# POTOMAC YARD

LANDBAY H & PARTIAL I - DSUP # 2004-0048

Docket Item #9 A&B  
Development Special Use Permit #2004-0048  
Street Name Case #2006-0001

Planning Commission Meeting  
October 3, 2006

Figure 1: Illustrative Plan

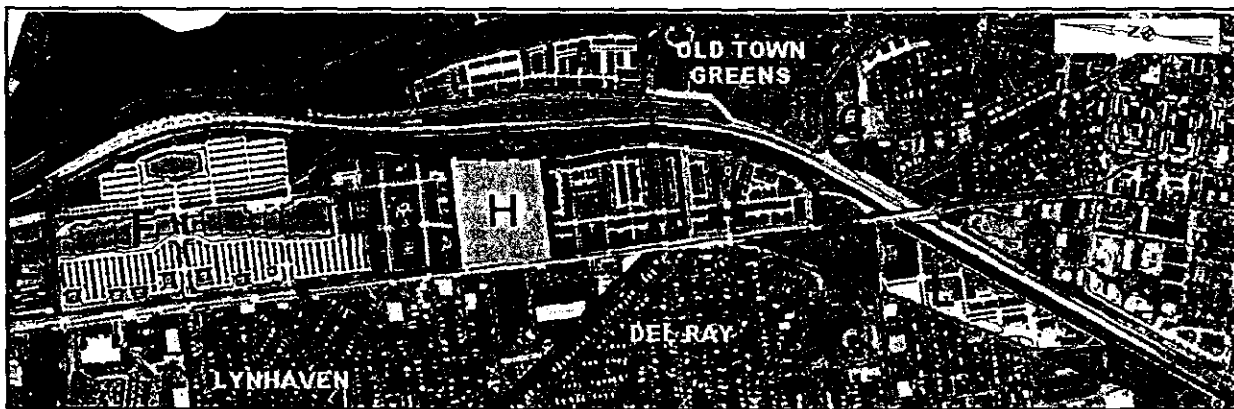
I tried to send the speakers form in last night on your web site and it would not go through, and I tried again this morning and it still would not go through. I want to address the Commission regarding 9 A-B, #2004-0048, specifically page 63 (para 1), page 4 (Figure 1), and page 14 (Figure 17).

The first sentence of paragraph 1 is vague: "A future pedestrian bridge may be located to the east of the site." Where is the bridge going to land on the east side? There appears to be a bridge in Figure 1. Does that illustrate the east side landing? If so, then the developer should be required to deed the landing site easement to the City before Potomac Greens is completed. There is no reason to wait. There is no doubt that the future location of that bridge landing site affects property values in Old Town Greens and Potomac Greens. Potential buyers should be told where the bridge landing site is on the east side.

Figure 17: Regional Open Space

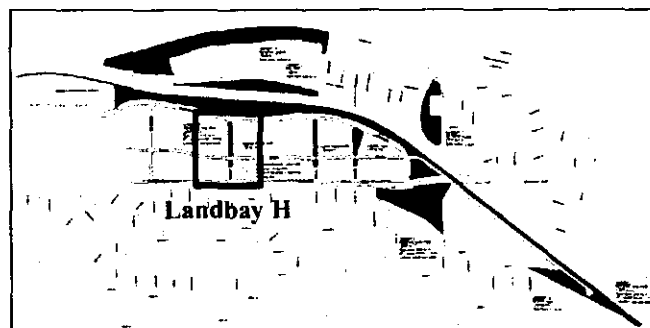
The green labeled open spaces are shown in Figure 17, but the resolution is too low for anyone to read the captions associated with each landbay. Can you e-mail me Figure 17 in a format that I

Figure 25. Turning Movements

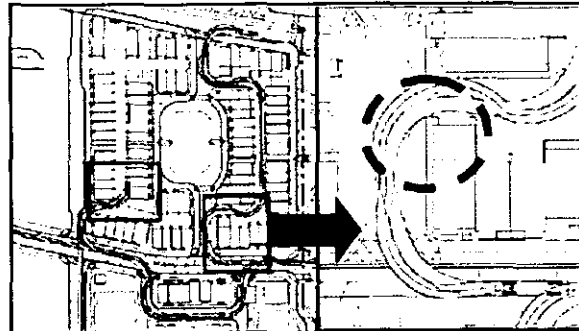
One of the issues raised has been whether the rights-of-ways are too narrow in Landbay H. The streets in Potomac Yard are 64 ft. (or wider), comparable to the typical 66 ft. right-of-way width in Old Town, which clearly accommodates fire trucks adequately. The area of conflict that leads to the fire issue is the geometry of the curb radii of the blocks in Potomac Yard, in relation to the length of the fire trucks.

Computer-simulated models reflecting the conflict show the worst-case scenarios with the largest apparatus owned by Arlington, Fairfax and Alexandria. As such, these models account for the rare times when the conflicts could occur. In part, the turning radius is impacted by the proximity of the buildings at the alley opening and at the turning radii. The purpose of the urban alley dimensions is to have the terminus of the alleys unnoticed or “hidden” by screening the views of the alleys.

**Figure 26.** Alternative Solutions (units removed shown in red, parking spaces removed shown in green)

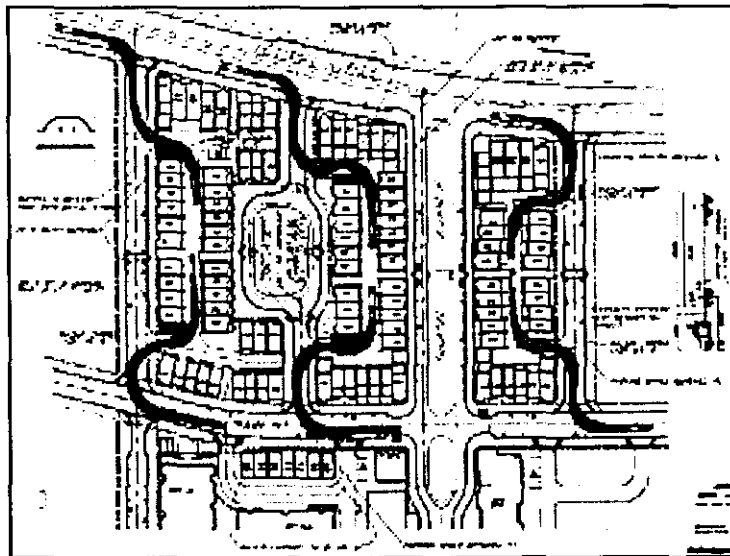
The community wanted to know whether Landbay H can move forward without the new fire station. If the fire station is not approved, the applicant will need to revise the site plan for Landbay H to meet emergency vehicle turning radii within the streets and alleys of the project. A preliminary plan revised to show the impacts to the site plan is included in this report. Four residential units will be removed, additional landscaping and screening will be required for the alleys, and approximately 5 to 10 parking spaces on several streets will be lost as part of this site plan revision.
